CONSTRUCTION SUMMARY				
Palmetto - Zadorra Estates Corp.				TEL:
PURCHASER: Loveth ORIAREBUN				
LOT / PHASE	REG. PLAN #	HOUSE TYPE		
30 / 1		Villa 5 Elev 1

Villa 5 36' LOT

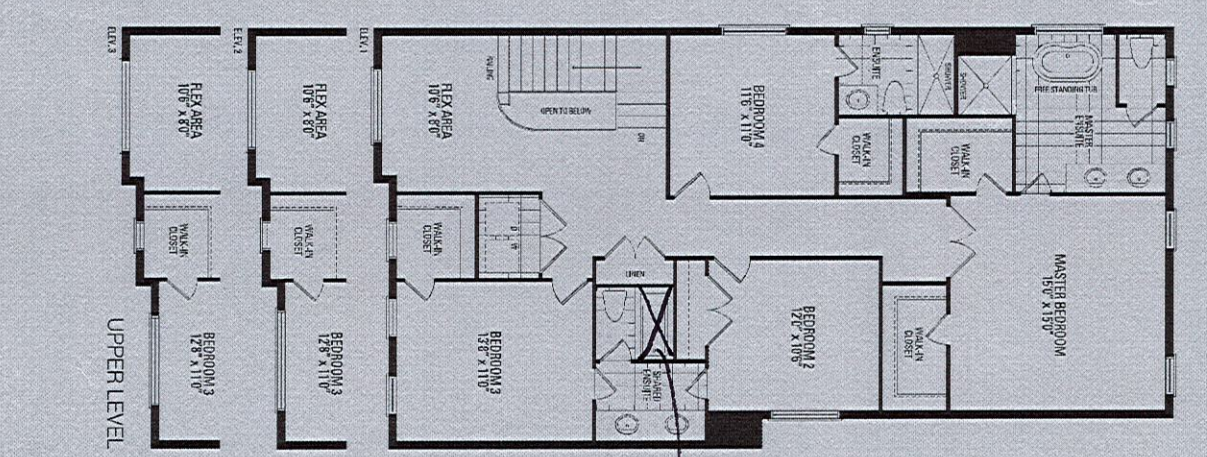
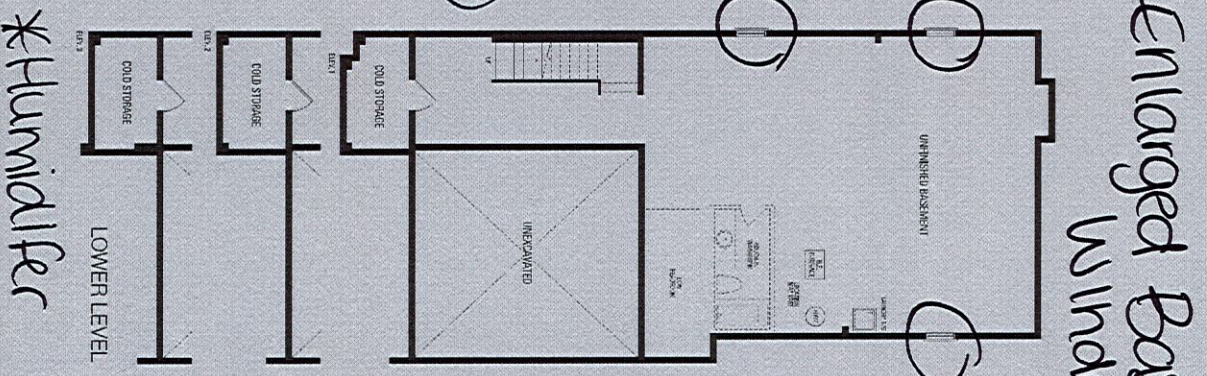
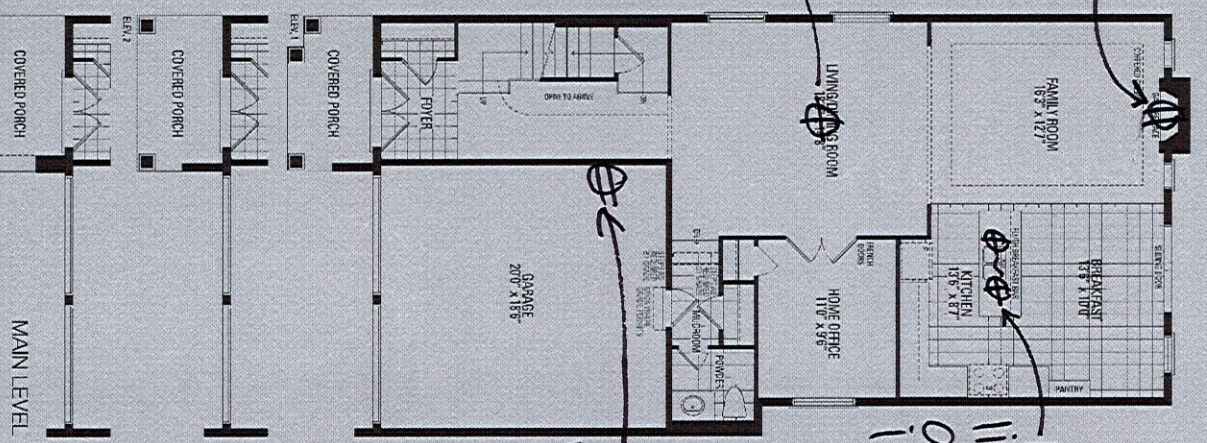
1 - FIRST FLOOR INCREASE CEILING HEIGHT FROM 9 FEET TO 10 FEET 14Jul23 Note:	
3 - ENLARGED BASEMENT WINDOWS (MAY REQUIRE WINDOW WELLS) - WINDOW IS 30 INCHES X 24 INCHES 14Jul23 Note:

1 - PLUG - ELECTRICAL PLUG - TO BE INSTALLED OVER FIREPLACE 26Sep23 Note: FAMILY ROOM - SEE SKETCH	
1 - STANDARD DINING ROOM LIGHT TO BE CENTERED BETWEEN LIVING AND DINING ROOM 26Sep23 Note:	
2 - ABOVE KITCHEN ISLAND - ADD LIGHT AND SWITCH - NO FIXTURE INCLUDED 26Sep23 Note: SEE SKETCH FOR APPROXIMATE LOCATION - IF CONSTRUCTION PERMITS	
1 - ELECTRIC VEHICLE ROUGH-IN PROVISION ONLY FOR FUTURE ELECTRIC CAR (CONDUIT FROM BASEMENT INTO JUNCTION BOX IN GARAGE WITH PULL STRING, NO WIRE) 26Sep23 Note:

1 - HUMIDIFER 26Sep23 Note:	
-----------------------------------	--

1 - HOSE BIB - EXTERIOR FROST FREE 26Sep23 Note: 1 @ REAR	
1 - WATER LINE FOR FRIDGE - ROUGH-IN ONLY 26Sep23 Note:	
1 - TUB TO SHOWER CONVERSION - 5 FOOT SHOWER WITH SLIDING GLASS CHROME DOORS IN LIEU OF TUB INCLUDES SHOWER POT LIGHT 26Sep23 Note: ENSUITE 2/3

*10' ceiling on first floor
*Humidifier
*Waterline r/i for fridge
Orientation of home may be reversed and purchaser agrees to hold same. Steps and porches may vary at any exterior entrance ways due to grading variance. Actual usable floor space may vary from the stated floor areas. All renderings are artist's concept. Dimensions, specifications and architectural detailing subject to modifications. Roofline and adjoining model types may vary due to siting. E. & O. E. May 2023
